# IAR Supplementary Information

Client: Genex Power Limited

Job No.: 60544566

This supplementary information has been prepared in response to comments on the final IAR received from DES on 29 January 2019 (refer to Appendix A of this Supplementary information). It also sets out the results of additional surface water sampling undertaken in February 2019, the scope of which was discussed and agreed with DES. This report should be read in conjunction with the final IAR. Capitalised and defined terms in this report have the same meaning as in the final IAR.

**Figure 1 Major ion concentrations (in meq/L) of the Middle Spring water sampled in February 2019, compared to water associated with the site facilities and monitored groundwater**

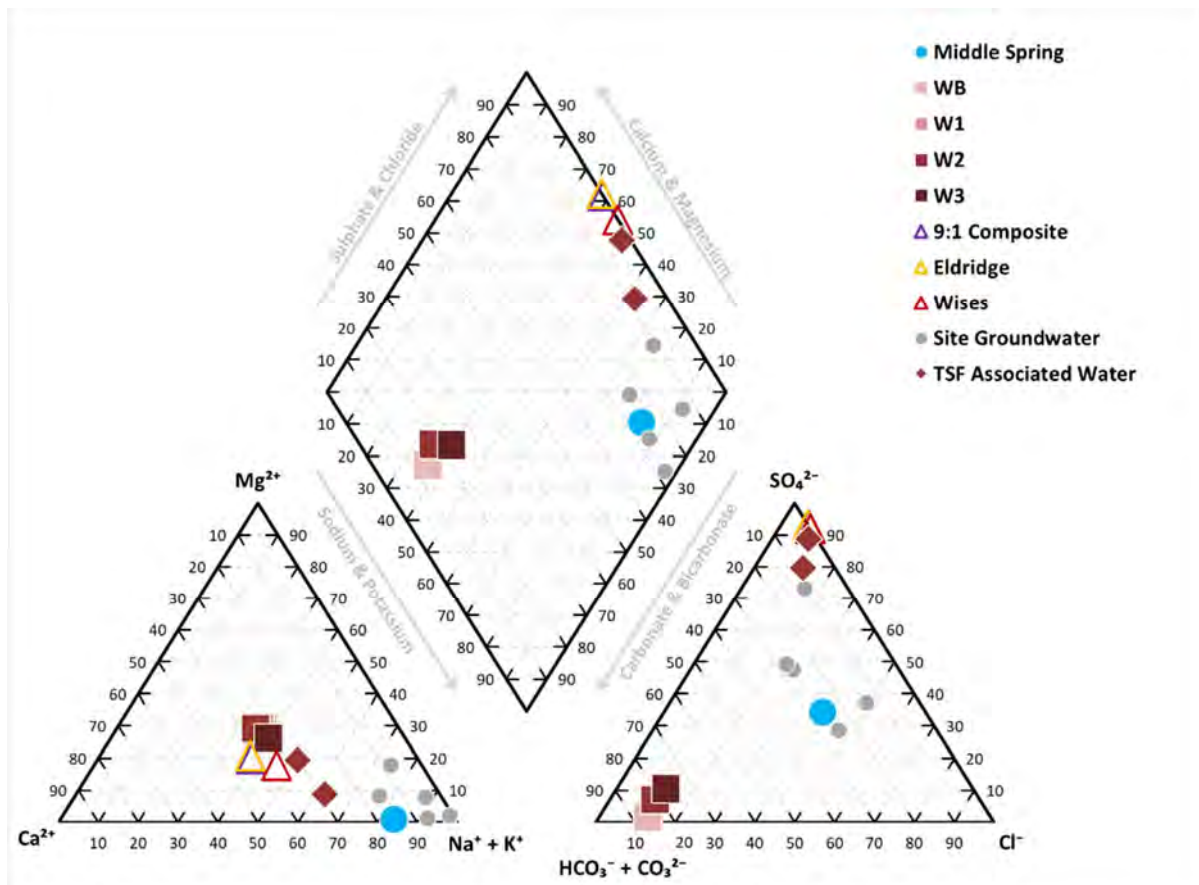
DES has previously commented on the lack of evidence in the IAR to support the assertion that Middle Spring is not hydraulically connected to the groundwater regime of the proposed release area. In response, the proponent has agreed to assess potential connectivity as part of "water modelling refinement and design phase work", however, this information should be provided in the IAR.

Update the IAR to include evidence to support the assertion that the Middle Spring is not hydraulically connected to the proposed release area groundwater regime. In the absence of this evidence, hydraulic connection between Middle Spring and local groundwater should be assumed.

Recent field sampling undertaken on 19 February 2019 included water sampling from Middle Spring. The water samples were compared to (i) water previously collected from the Wises Pit, (ii) water associated with the tailings storage facility (e.g., seepage) and (iii) groundwater to the west of the site, to establish whether the water chemistry indicated an impact associated with a hydraulic connection between the pits and Middle Spring. Middle Spring major ion concentrations display very little evidence of impact from either the pits or the tailings storage facility, with the spring sample similar in concentration to the unimpacted groundwater monitored to the west of the site facilities (Figure 1).

A groundwater assessment undertaken by AGE in January 2019 and attached in Appendix E reviewed the potential impacts of the Project on Middle Spring (SPR482), the model assuming that a connection between the pits and the spring may be possible. The spring is located approximately 4.8 km west-northwest of the Project which is a significant distance, and close to the edge of the model domain. The modelling showed that Middle Spring, if connected, would be predicted to be impacted by less than 0.2 m based on a very conservative steady state assessment. This is illustrated in Figure 7 of the AGE assessment (see Appendix E).

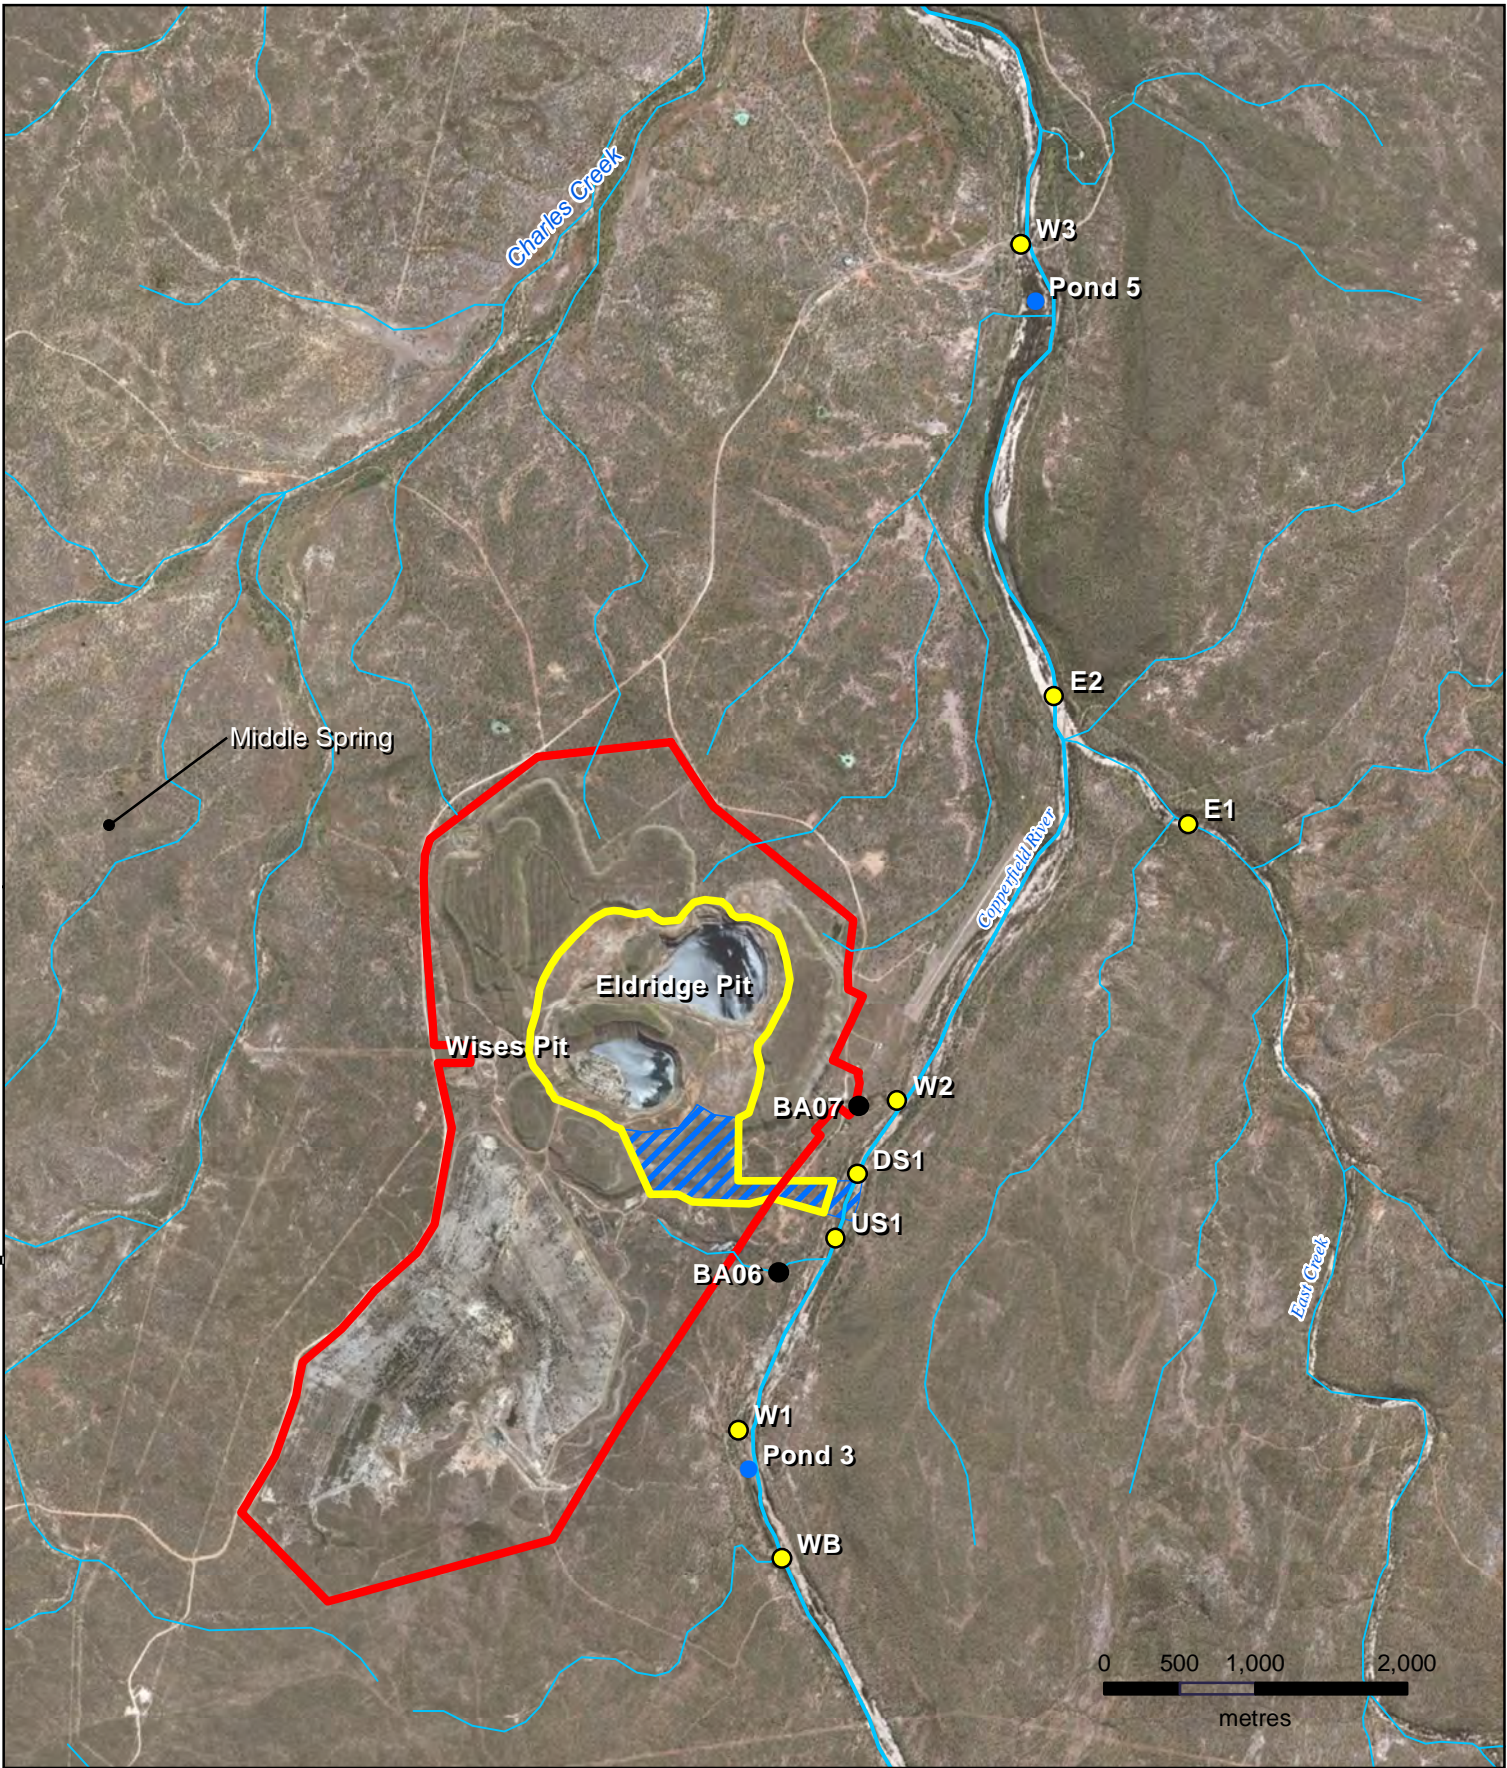
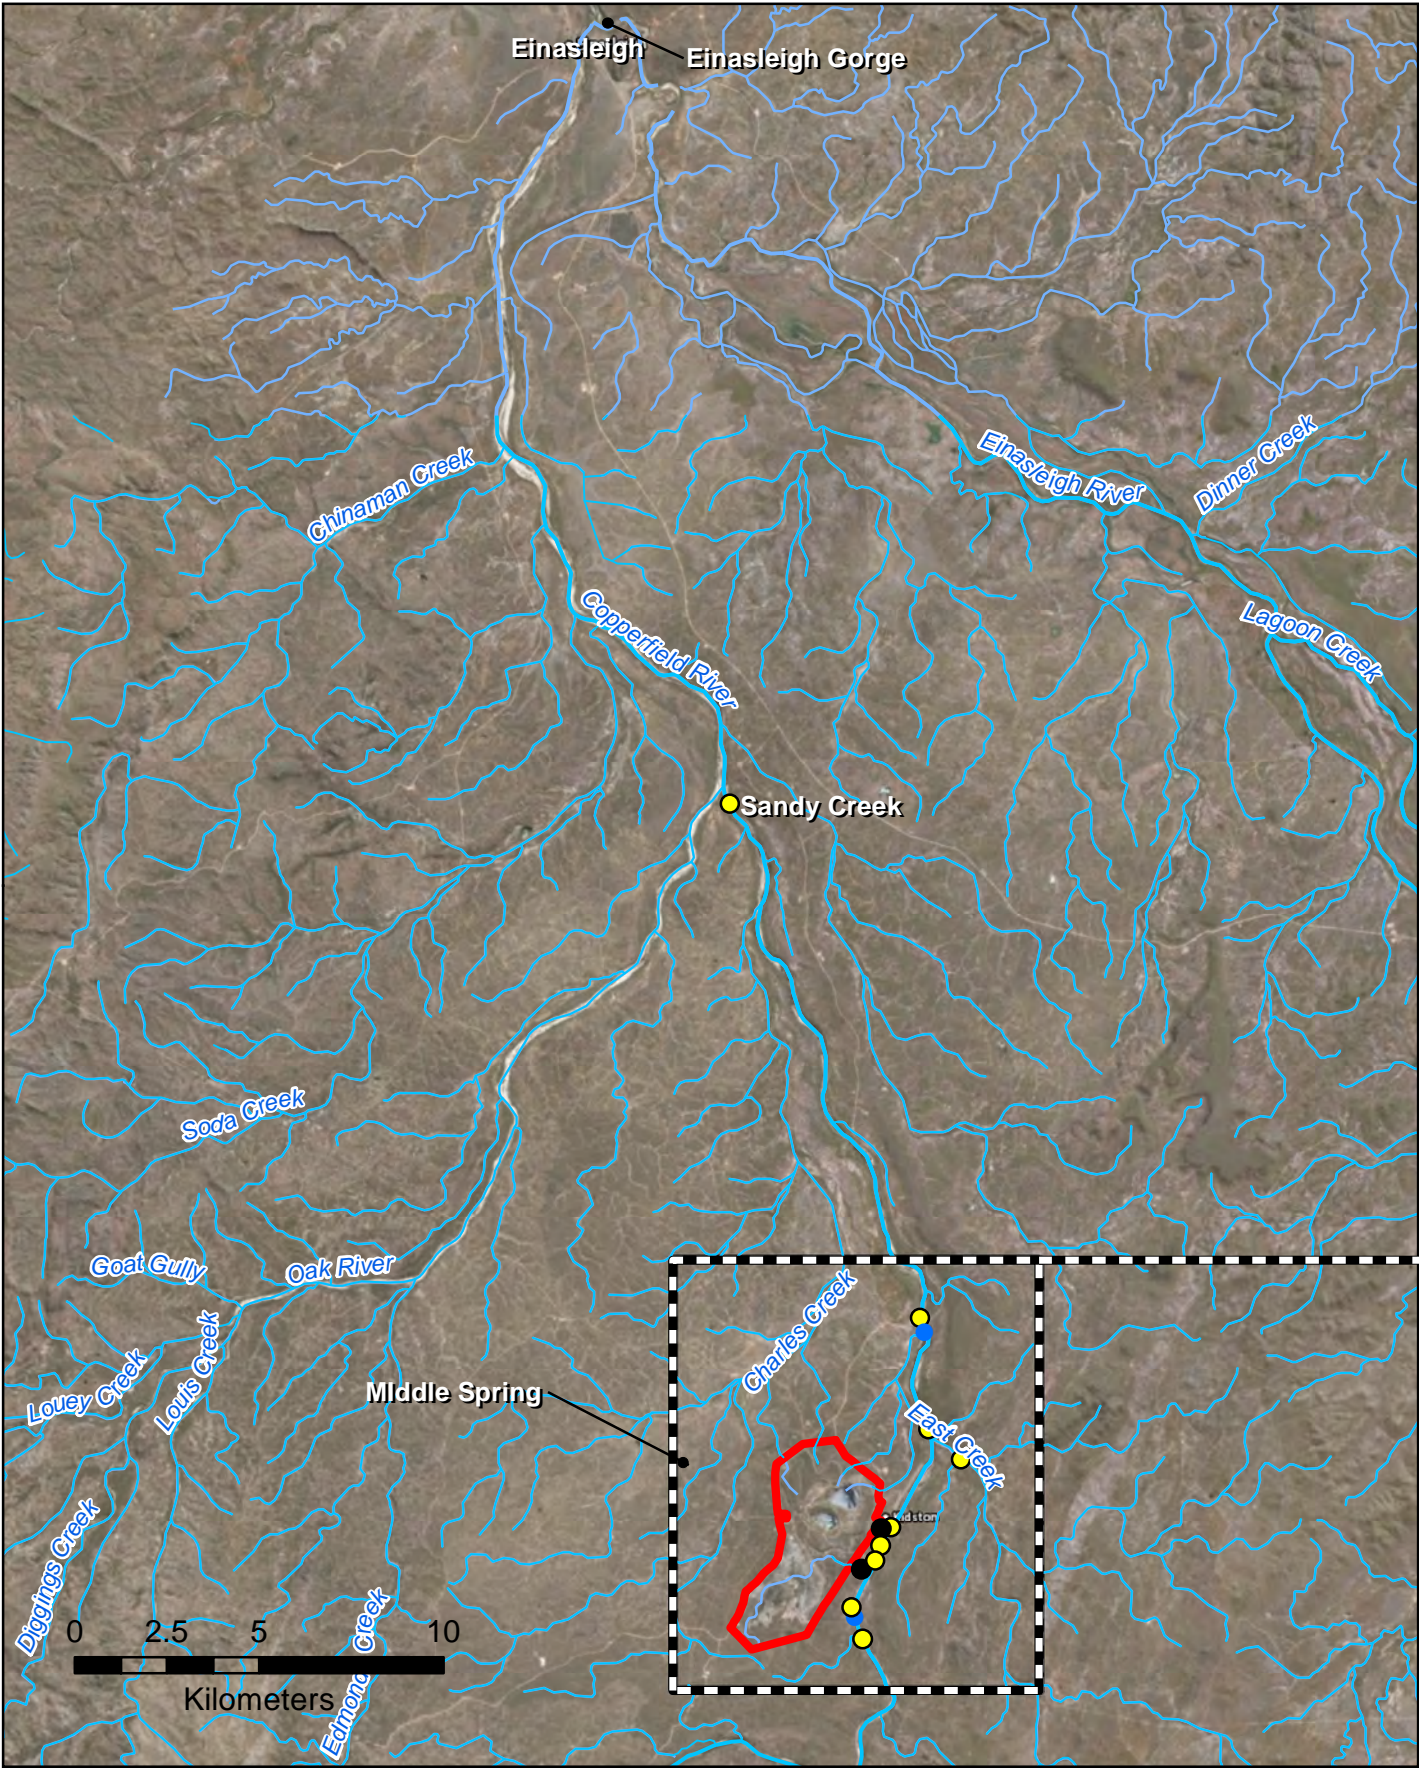
Include a map in the Executive Summary or the front end of the document to clarify the location of features discussed in the Executive Summary.

Figure 17 of the IAR includes locations of all relevant waterways. An additional overview of significant features which can be viewed in conjunction with the Executive Summary is presented in Figure E1 below.

**Figure 2 Construction phase mixing zone dissolved zinc concentrations as predicted by CORMIX – Scenario 1**

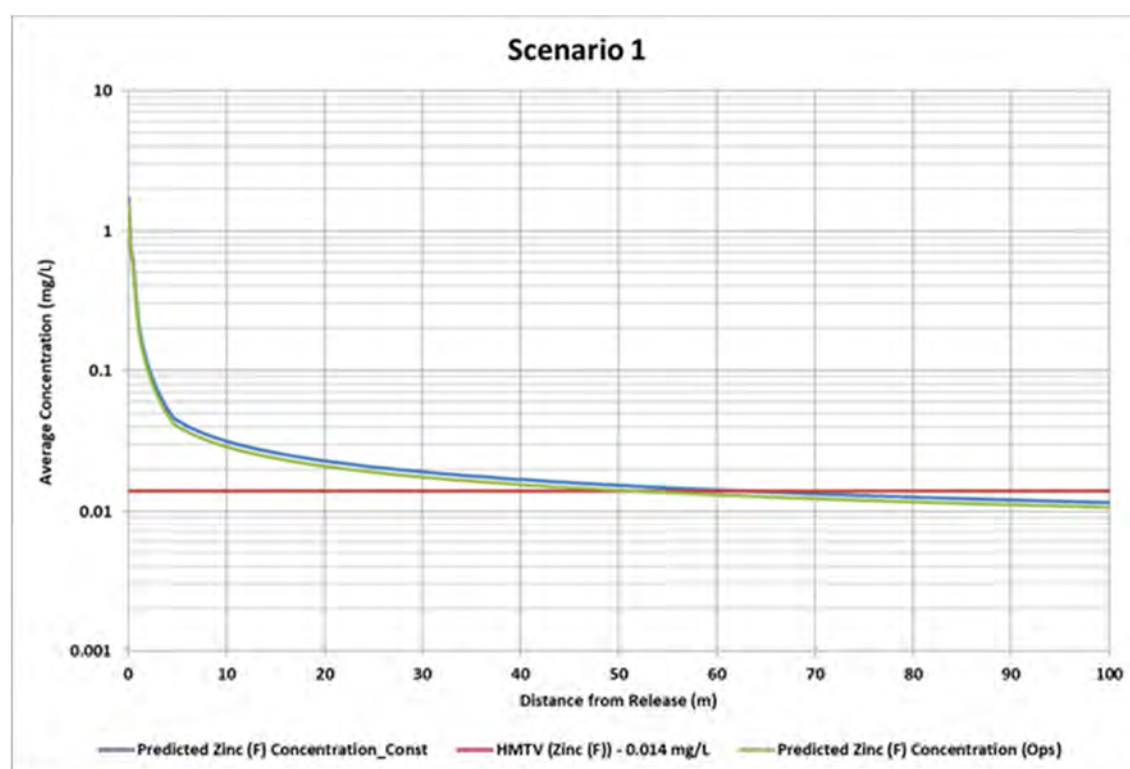
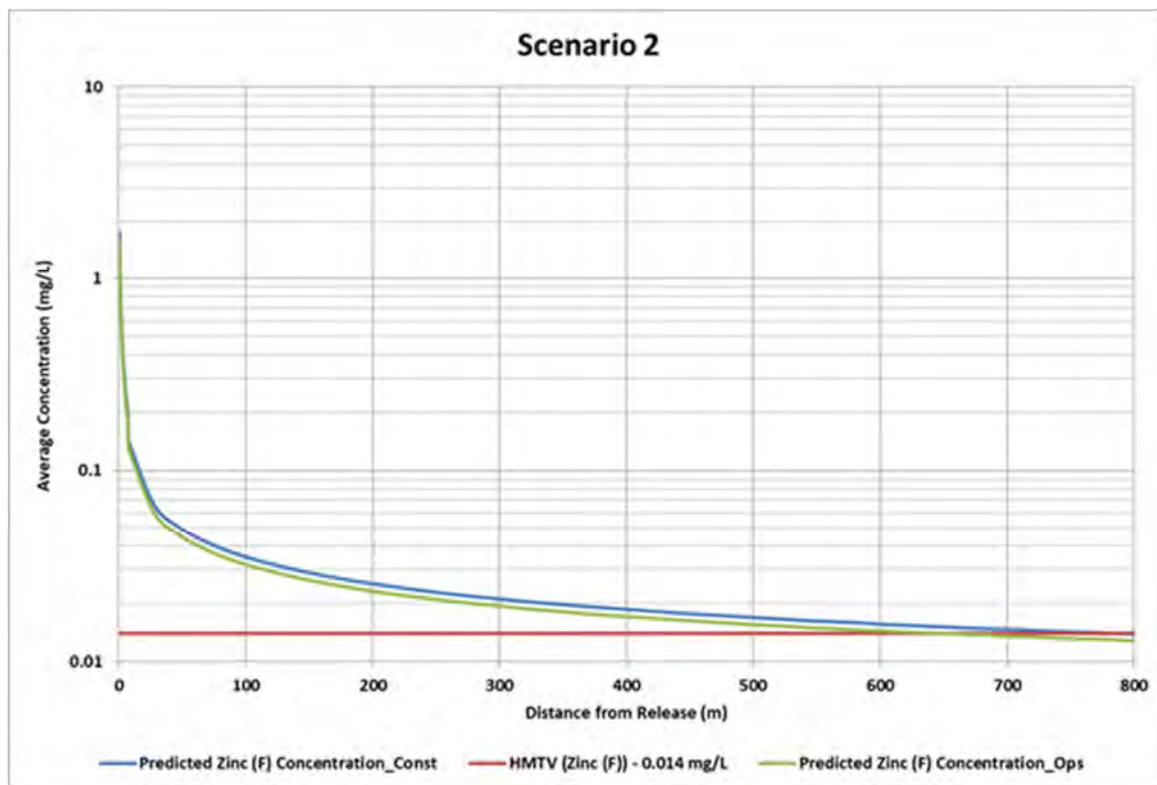
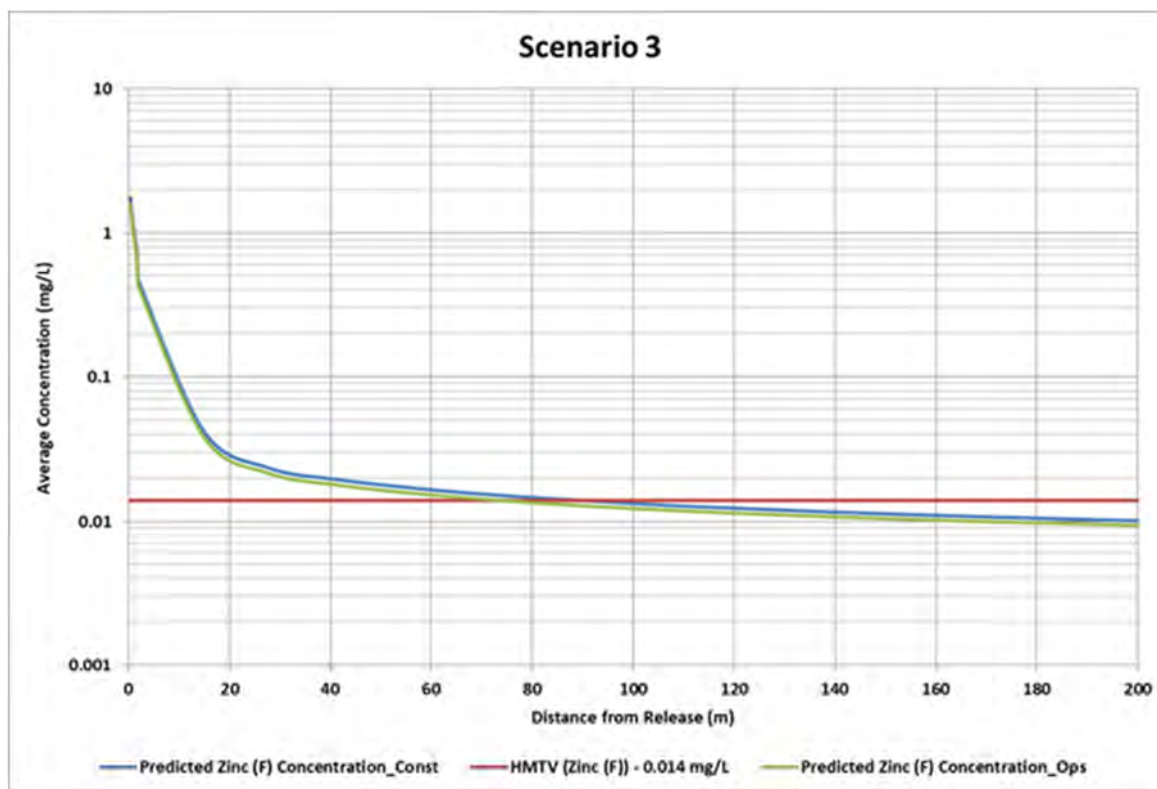
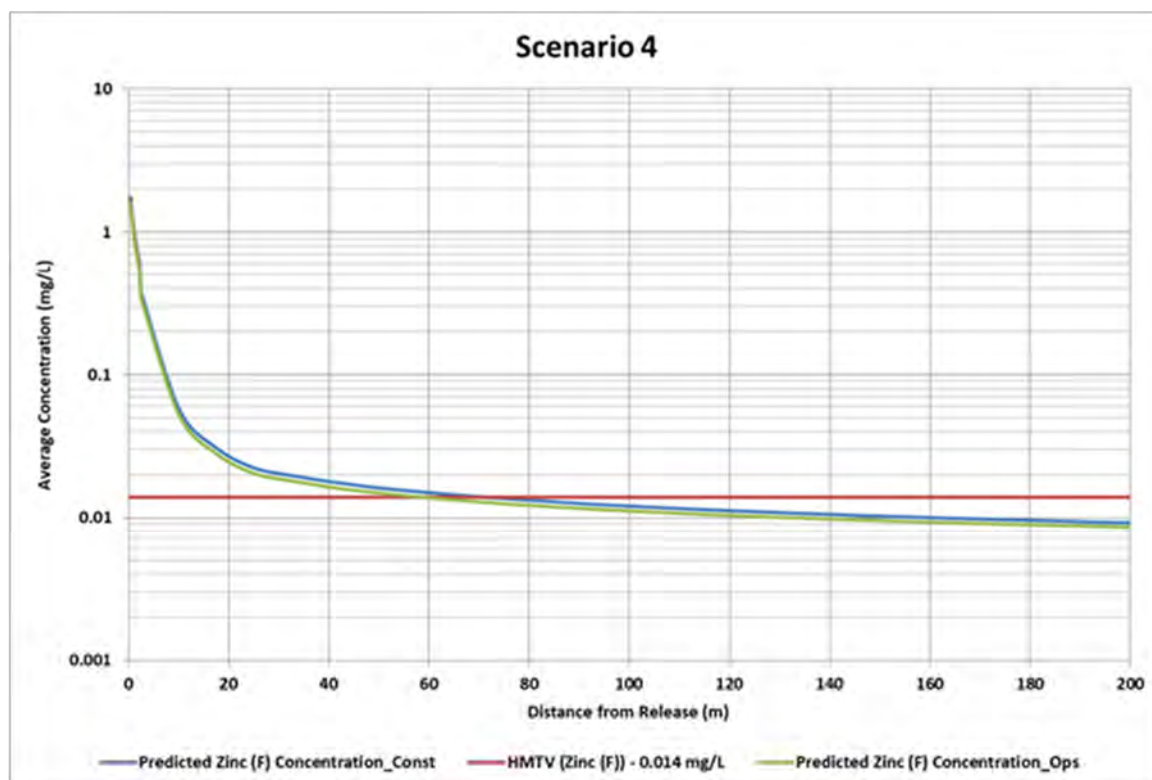
It is also suggested that the outfall structure may not be complete and that initial releases during the construction phase may be via a simple outfall structure. Mixing zone modelling for operation included two different conceptual diffuser configurations. Therefore, as per previous comments, the modelling for the operational phase does not provide the worst case scenario of a simple/temporary outfall structure. Mixing zone impacts of entrained metals in sediments should also be addressed.

Provide mixing zone modelling representing the construction release conditions (source water, maximum release volume, outfall structure).

CORMIX modelling has now been undertaken for the construction phase. Modelling was undertaken for the same four scenarios assessed for the operational phase of the Project (refer to Section 6.2.1.4 of the IAR for detail), however assumes a higher dissolved zinc concentration in release waters than for the operations phase. The operations phase assumed a maximum dissolved zinc concentration in release water of 1.59 mg/L which is the maximum resulting from the 9:1 mix of Eldridge Pit to Wises Pit. The construction phase assumes a maximum dissolved zinc concentration in release water of 1.75 mg/L which is the maximum concentration observed in Eldridge Pit (the most likely source of release water during construction).

The estimated mixing zone length for temporary construction releases is summarised in Table 4 along with Figure 2 to Figure 5. From the results it can be seen that the proposed releases are subject to initial mixing within the near field and that predicted water quality within the mixing zone reaches the WQO for dissolved zinc, being the contaminant of most concern, within a **maximum** distance of 772 m. Three out of the four modelled scenarios indicate a much smaller mixing zone of between 62 and 86 m downstream, therefore it is predicted that the mixing zone in most cases will be 86 m or less.
